**PLANS AND DOCUMENTS
referred to in the PDA
DEVELOPMENT APPROVAL**

Approval no: DEV2021/1232

**RE: Traffic Engineering Advice
Lot 110 Multi Storey Car Park, Market Street, Maroochydore City Centre**

A review of Council's Further Issues letter for MCU 2021/1232/4 has been undertaken and a response to Item 1a and 1b provided below.

Figure 1 – Installation of rubber lane separators on ramp

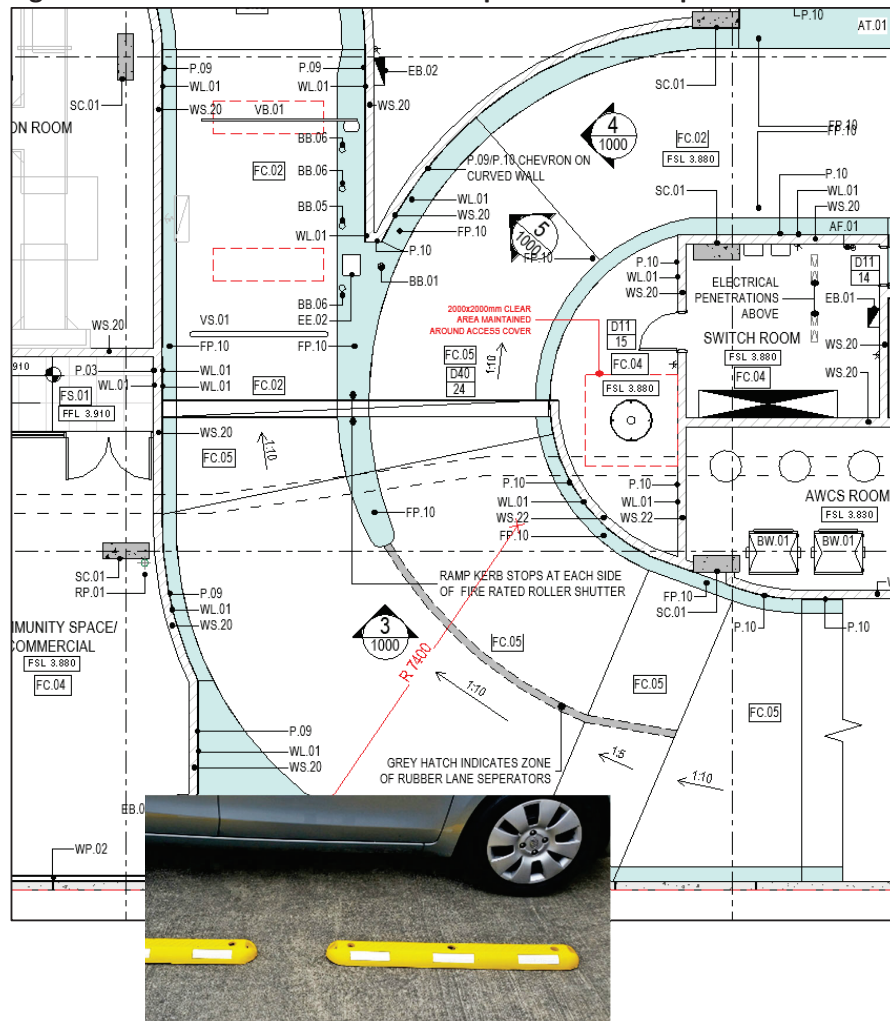
The requested change appears to be shortening of the ramp divider though the plan does not have a proper clouding to demonstrate the requested change. Nevertheless, the proposed change does not seem to comply with the AS2890.1. The applicant is requested to submit a letter from an RPEQ specialised in transport engineering stating that the proposed change in the ramp meet the requirements of the AS 2890.1.

A review of the curved ramp has been undertaken with reference to Clause 2.5.2 (b) of AS2890.1. To achieve compliance with requirements it is proposed to install kerb/lane separator as shown in Figure 1 below. Devices range from 150mm to 265mm wide and provide suitable clearance for the outside of a wheel to touch the separator before the body of a vehicle can contact an opposing vehicle. This treatment is considered suitable and compliant with the requirements of AS2890.1.

Figure 2 – Compliant Sight Lines on exit ramp

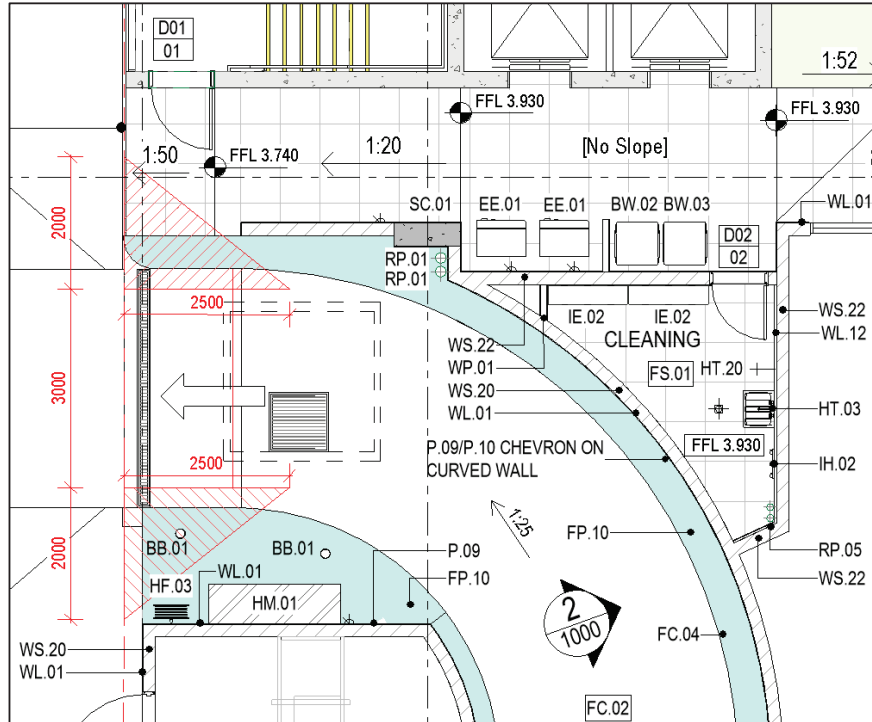
Please also note that the exit ramp near the interface of the property boundary does not have an adequate straight length for a car to position itself perpendicular to the interface of the footpath/road. This compromises the safety of the pedestrians and other road users by not having an adequate line of sight from the exit vehicles. The RPEQ is required to assess and provide a road safety audit on the design.

A review of the sight lines has been undertaken to ensure the sight triangles comply with the requirements of Figure 3.3 of AS2890.1. As shown in Figure 2 below there are no obstructions and compliance is achieved. The alignment of the exit ramp results in very low vehicle speeds.

Market Lane is also a one lane, one-way, narrow street with a low speed environment. The drainage grate at the exit also provides an audible cue for pedestrians to hear a vehicle exiting the car park. Given the low speed environment and the available sight lines for visual cues and drainage grate for audible cues, the driveway exit is considered suitable.
